City of Sycamore 2022 Wastewater Treatment Plant Demo

Addendum #2

February 8, 2023

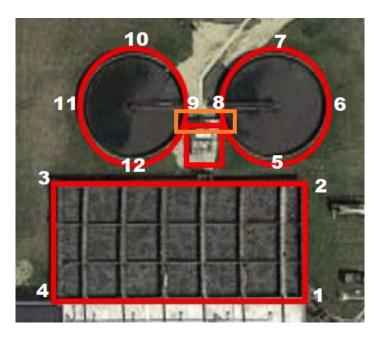
- 1. **Clarification:** The area in orange shall be considered incidental #3 Demolition of Pump House Onsite.
- 2. **Clarification:** Depths of tanks and distances above grade can be found below. A complete set of the original plans can be downloaded as Addendum #2 Attachment on our bidding website.

Loc	Depth of	Top of
	Tank (Top	Wall to
	of Wall to	Adjacent
	bottom of	Grade
	Tank)	
1	19.5′	8′ +/-
2	19.5′	8′ +/-
3	19.5'	8.5' +/-
4	19.5'	8' +/-
5	14.0'	4.5' +/-
6	14.0'	6′ +/-
7	14.0'	6′ +/-
8	14.0'	6′ +/-
9	14.0'	6′ +/-
10	14.0'	6′ +/-
11	14.0'	6.5' +/-
12	14.0′	5+/-
